COMPREHENSIVE ROADS PLAN Fairbanks North Star Borough

Official Maps and Policies

April 2024

348:

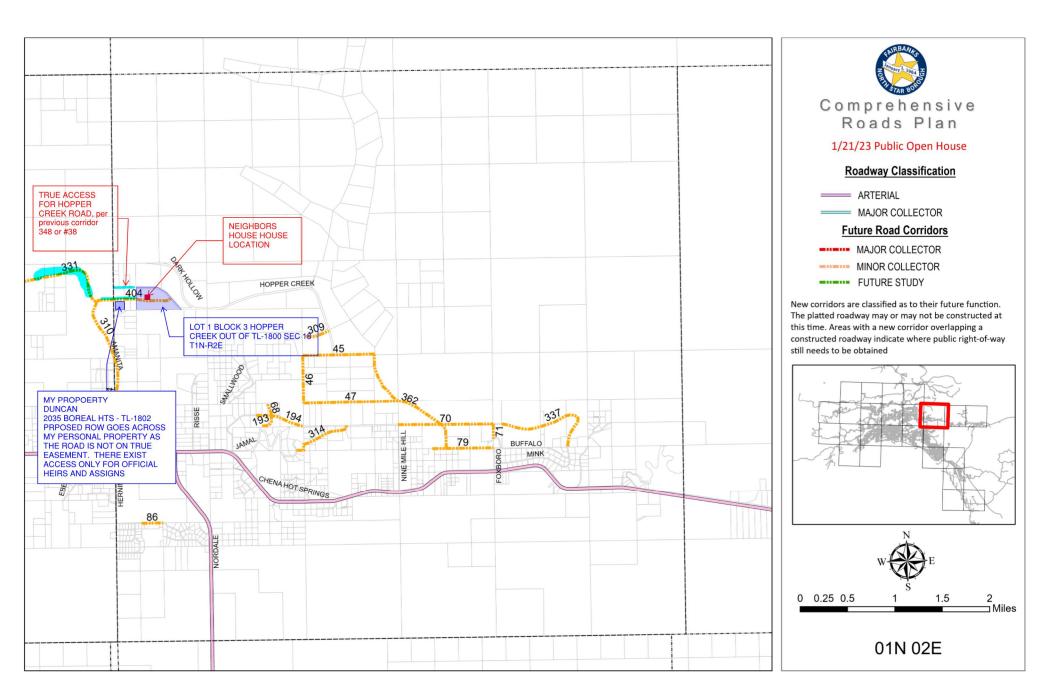
We would like to know the reason why corridor #38 was suggested or what its purpose is.

| Corridor # | Date | Form | First name | Last name | Affiliation | Comment | Response/How Addressed in Revised Maps |
|------------|-------|----------|------------|-------------|-------------|--|--|
| 348 | 10/21 | email | Tom | Duncan | | NOTE: This comment has several attachments in its PDF submission. Kellen, Thank you for giving us the opportunity to comment on these proposed road plans. I have comments on the following areas and have highlighted those on sheet 24 and on the map, see attached. -Most importantly 404 as this proposed ROW directly affects me as there is an easement on my property -331 -348 348: We would like to know the reason why corridor #348 was suggested or what its purpose is. | Corridor 348 has been removed from the plan. |

331:

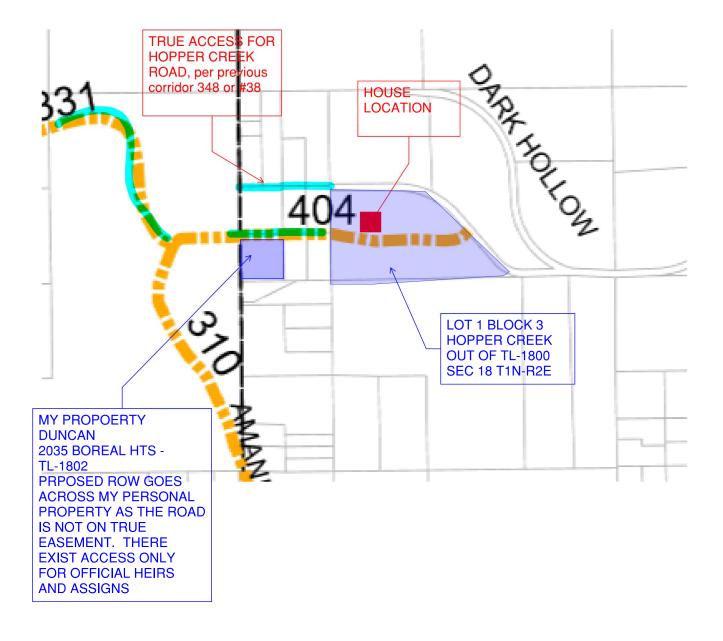
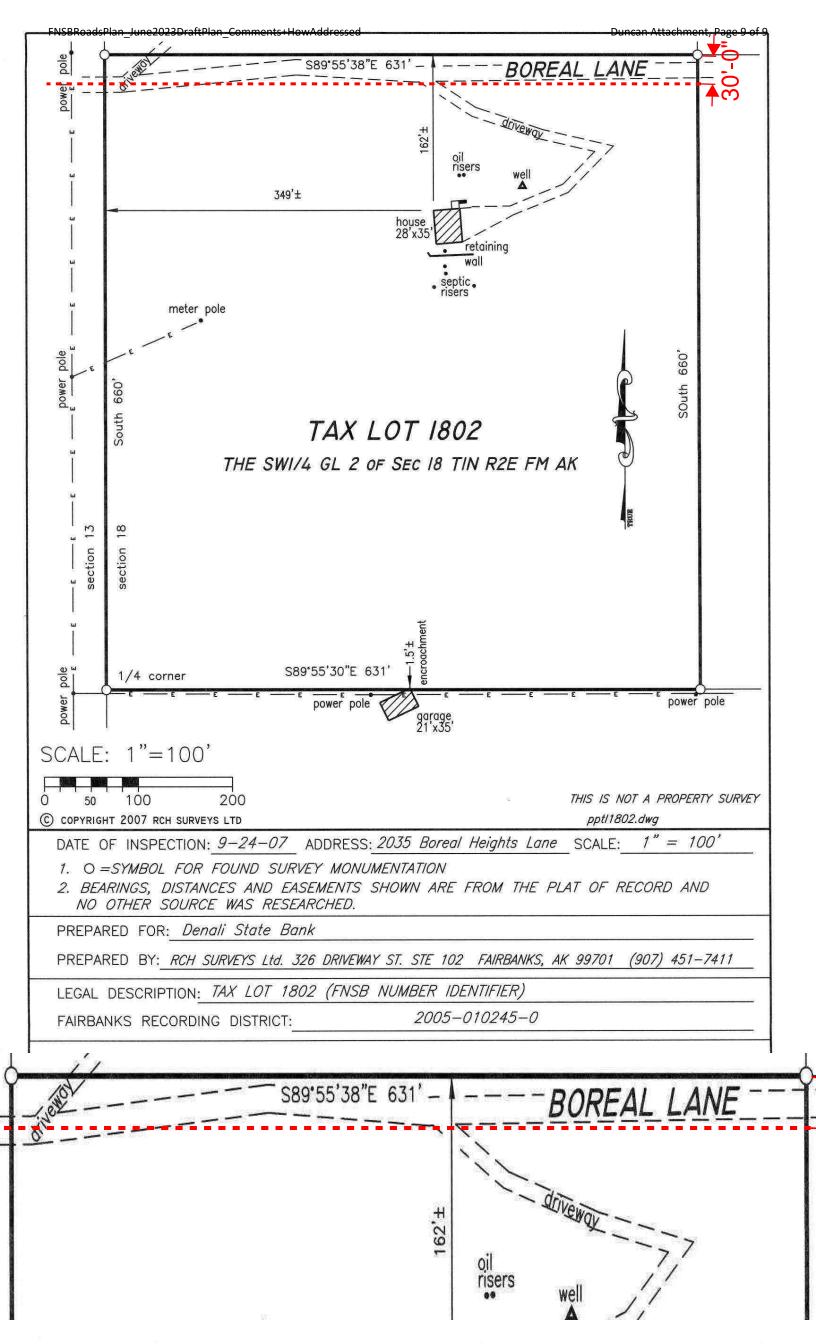
First 331 as shown on the map does not appear to match the description on page 24. This route per the map appears to connect amanita and ESRO, not amanita and Boreal hts as indicated on 24.

Discussion of Corridor 251 in the current draft of the FNSB Comprehensive Roads Plan.

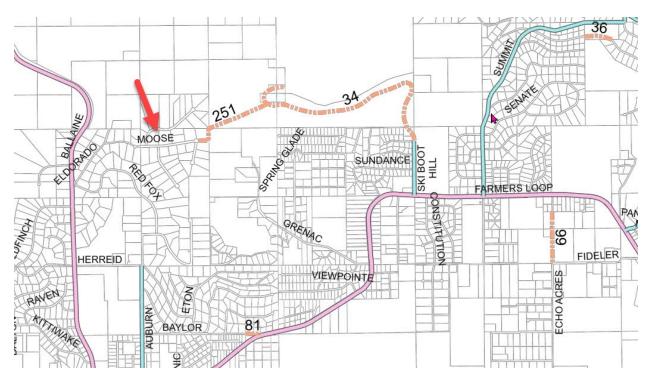
The following is my letter of this April that was intended to be a comment with details on the preceding plan draft but was not included in the most recent summary of comments. [Which may be due to my late filing. This may be a good time to thank the Planning Department and the mayor's office for their prompt and courteous attention to my comments.]

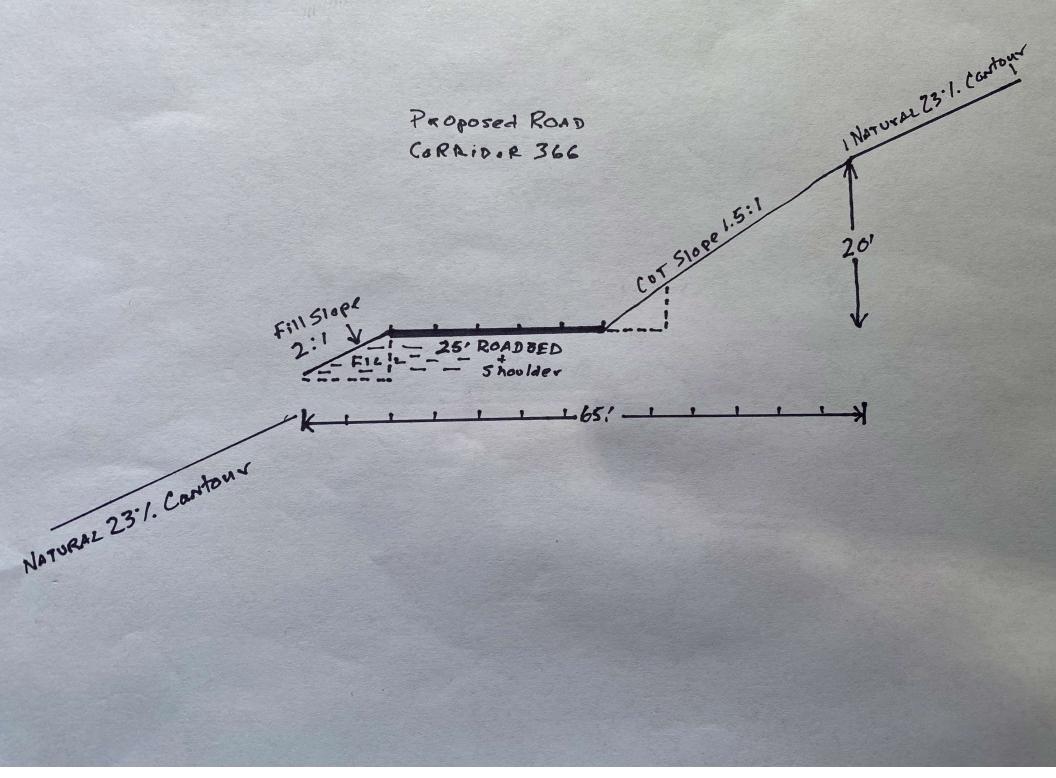
number of comments. There is unquestionably strong local public support to remove proposed corridor 366 from the borough plan.

We request removal of corridor 366 from the plan which will result in a cost savings to borough taxpayers by refocusing future borough road planning efforts to areas that are practical and of benefit to the majority of affected parties.
